**Royal Borough of Kensington and
Chelsea Basements Policy**

Hydrologic Review of Basements,
Publication Planning Policy

Revised Issue | 27 August 2013

Job number 230276-00

Drawing Title
TYPICAL SITE DESCRIPTION

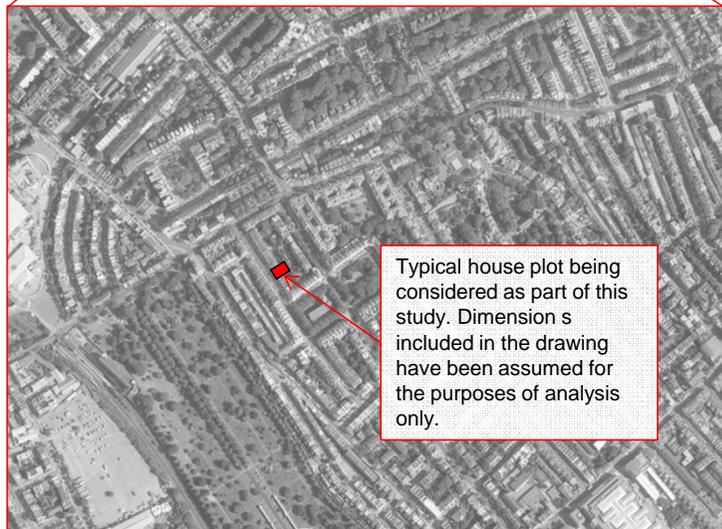
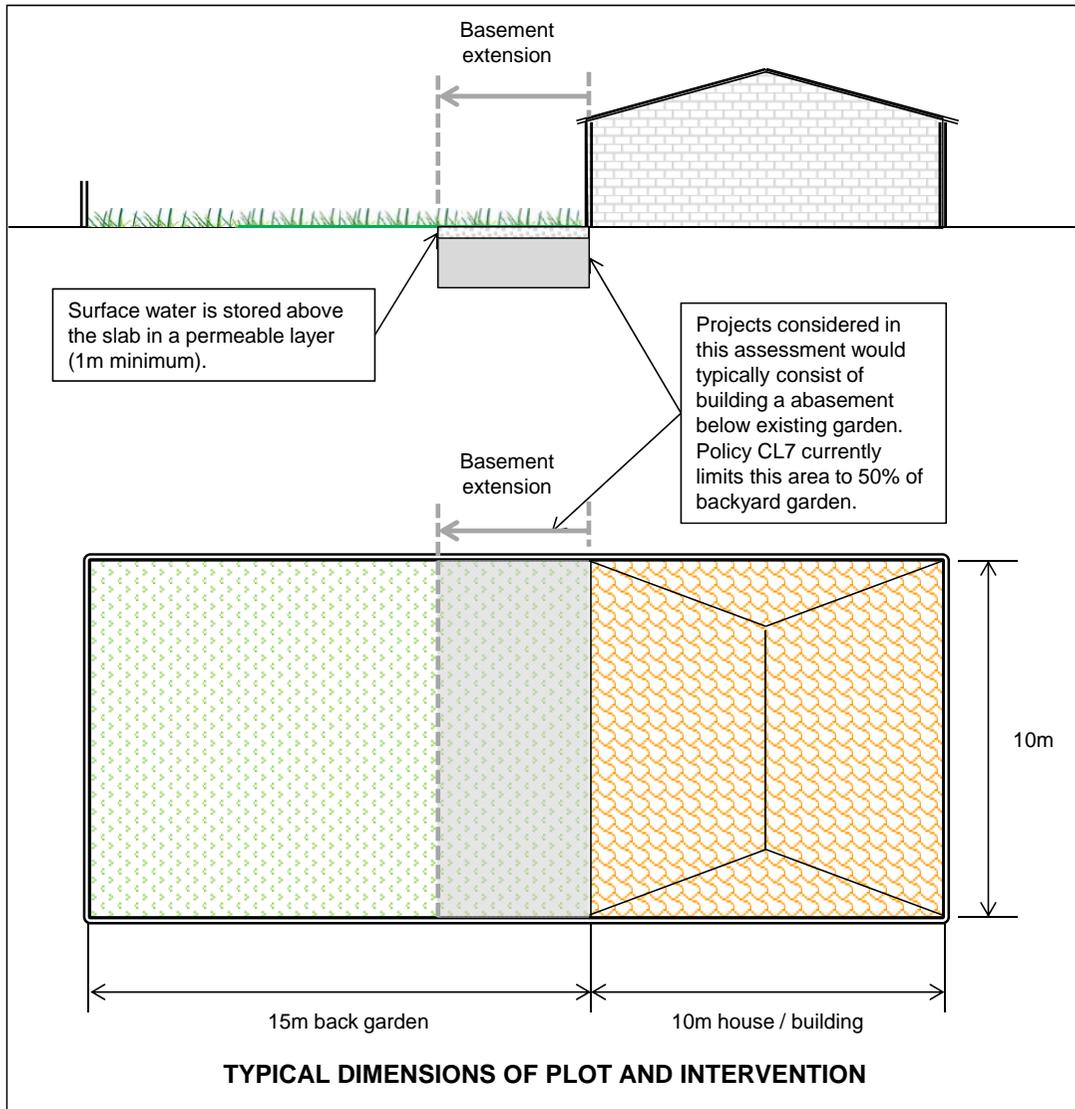
For the purposes of this qualitative hydrological evaluation, a typical site will be used as the basis of assessment and discussion. Figure 3 illustrates the typical layout and section of a site being considered under Policy CL7. This can be described as follows:

- Narrow plot with the residential house at the front and a back garden.
- The boundary of the site follows the extent of the back garden.
- The proposal to be considered would typically involve a basement extension to the property below the garden area.
- The garden is considered to be a lawn or landscaped area that enables natural infiltration of surface water.
- Projects are located either on London Clay or on RTDs. These are the main geotechnical conditions for the Borough as described in Section 2.2.
- Neighbouring properties have similar scale gardens to the side of the site and there is a garden backing onto the site.
- Neighbouring properties have sufficient drainage typical to the area.
- The back garden of the site does not drain to the local public surface water sewer. The only means of discharge is through natural infiltration.

Drawing Title
EXAMPLE STORMWATER MANAGEMENT STRATEGY

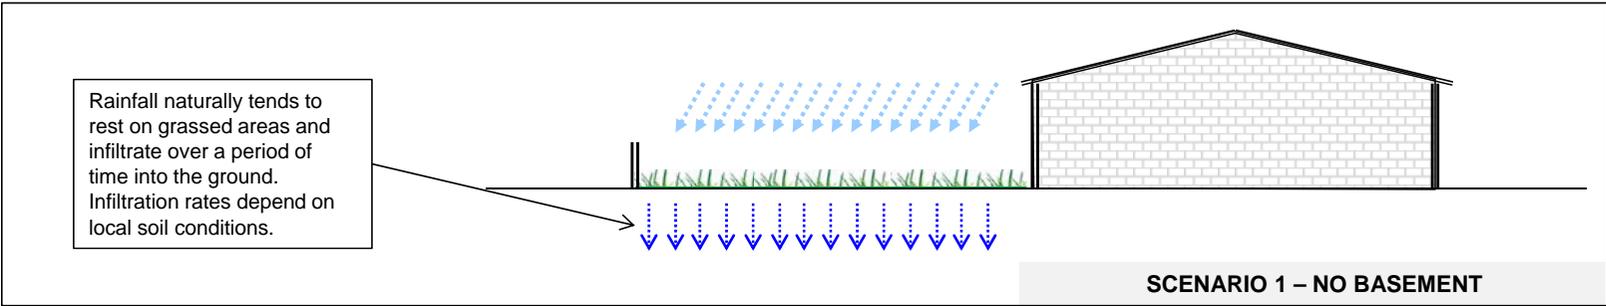
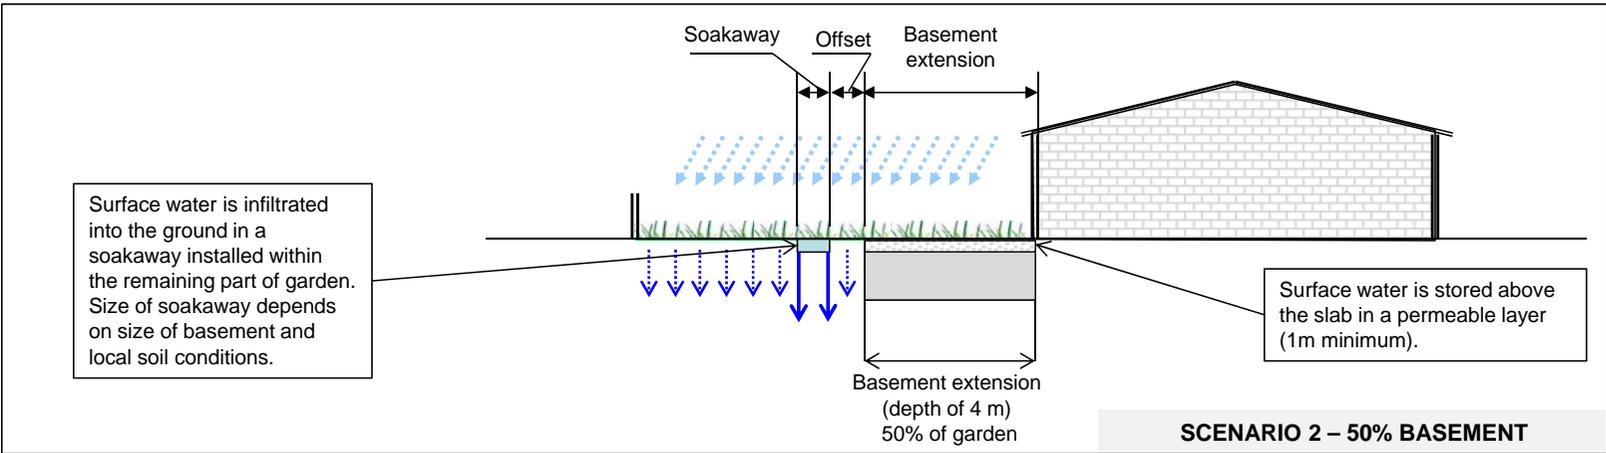
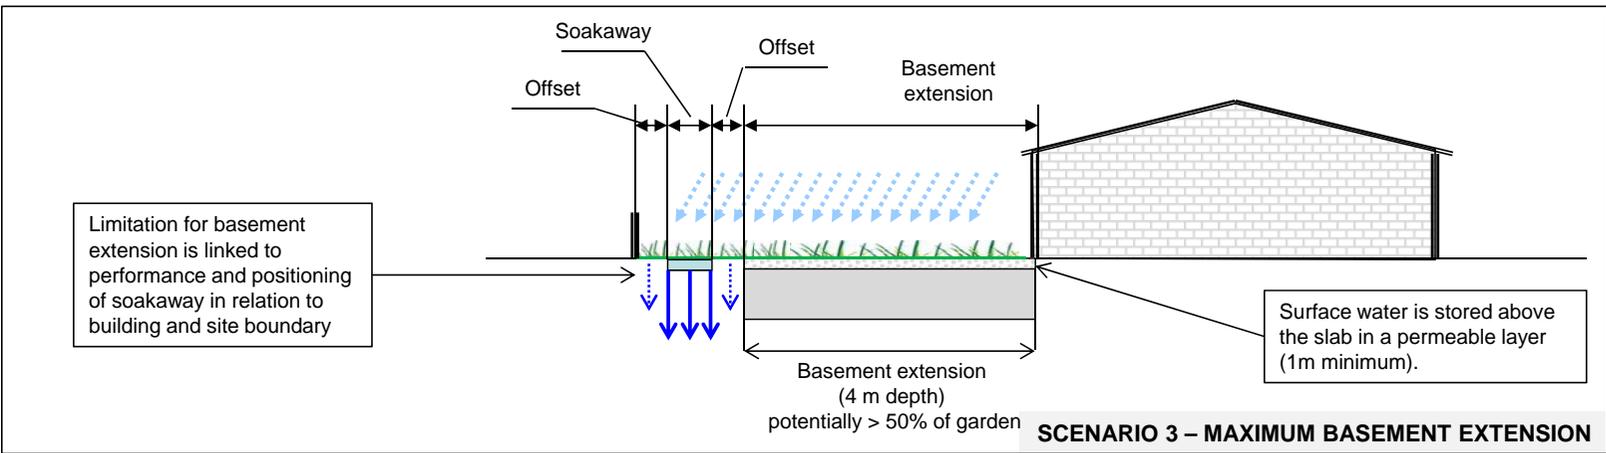
To demonstrate this, we have illustrated three scenarios on Figure 4. The scenarios are as follows:

Scenario 1 – No basement – this is a typical small site as defined above in Section 3, the garden allows natural infiltration of surface water into the ground.

Scenario 2 – 50% rule – a typical small site where Policy CL7 is implemented. A permeable soil storage zone is provided above the basement slab to provide attenuation and a soakaway is provided in the garden area connected to the storage zone to enable a discharge to ground.

Scenario 3 – Maximum Basement Extents – This scenario illustrates a basement extension where the constraints imposed by storm drainage are at the limits of design. Again attenuation is provided in a permeable soil zone above the basement slab and a soakaway is provided in the garden space. However, there is only enough space to position a soakaway within the setback required by building control for properties and the site boundary.

The above scenarios help to illustrate the following:

- Engineering methods are available which can be used to maintain or improve storm water storage and infiltration capacity within the site curtilage.
- A simple limitation of 50% may preclude innovative methods which improve overall drainage conditions within the Borough.
- There is a limit to the amount of garden which can be developed into a basement. To establish this limit, site specific assessment will be needed, a general rule cannot be applied.
